The Town of Hilton Head Island Regular Design Review Board Meeting

Tuesday, April 27, 2010 1:15 p.m. – Benjamin M. Racusin Council Chambers

DESIGN TEAM/ DRB COMMENT SHEET

PROJECT	Sylby Tub A	Apartments			DRB#	DR10001	9
DATE	4/27/2010	RECOMMEN APPROVE	D	RECOMMEND APPROVE W/COND		OMMEND [Y	
The composi "Hardi-plan' palette is a li commensura	or equivalent lattle vibrant. So the with the Des	iding is a big impr has generally been ome form of off –v sign Guide, and the	preferr white for e siding	at. Vinyl has historically ed as a low-maintenance the trim elements and valued tome down in co	e wood replica windows would oncert with the	nt. Color d be more	
	UIDE/LMO	COMPLIES	COM	MENTS OR CONDIT	IONS		
CRITERIA Structure is de		YES/NO/N/A					_
appropriate to neighborhood	the						
Promotes ped							
and circulatio	n btrusive and set						_
	al environment						
	al materials and						
colors							
	ctive vernacular						
styles							_
Design is app	ropriate for its						
All facades ar	e have equal						-
design charac							
Avoids mono							٦
or unrelieved							
	oof form with

Guiseppi's Awning Project

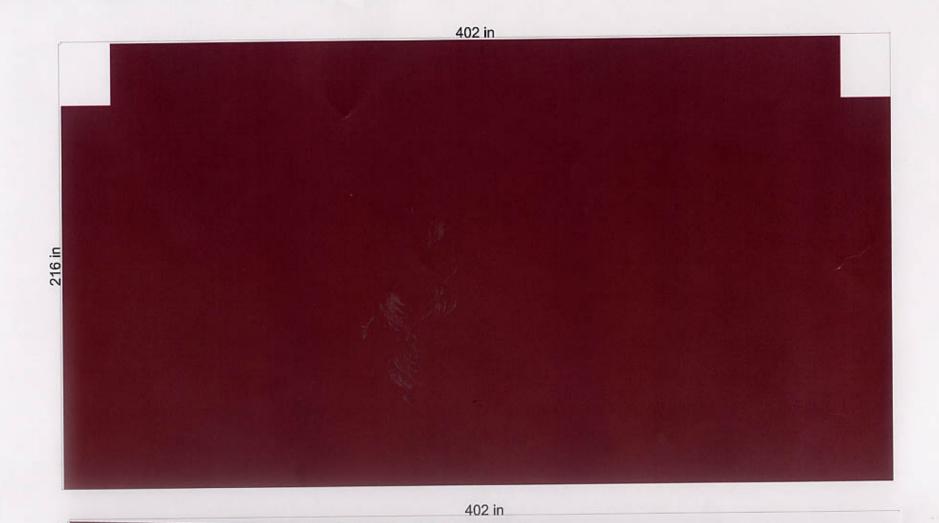
PROJECT	Giuseppi's F	Pizza (Shelter Co	ove)	DRB# DR100020
DATE	4/27/2010	RECOMMEN APPROVE	RECOMMEND APPROVE W/COND	X RECOMMEND DENY
Applicant ha for approval. application le approval, alt	Proper delineateaves too much hough if it is to	catalog for Board ation of the fence to interpretation. match the provide	I color approval at the meeting. will be required for review at th No cut sheet for the fence, whi ed examples, it should be accept ntained. New fence cannot cut	e meeting. The ch will be required for table. Access along and
	UIDE/LMO	COMPLIES	COMMENTS OR CONDIT	TIONS
CRITERIA Structure is de appropriate to neighborhood	the	YES/NO/N/A		
Promotes pede				
Design is uno	btrusive and set			
	al materials and			
Avoids disting styles	ctive vernacular			
Design is approuse	ropriate for its			
All facades ar				
Avoids monot or unrelieved:	onous planes			
Has a strong r enough variety visual interest	oof form with y to provide
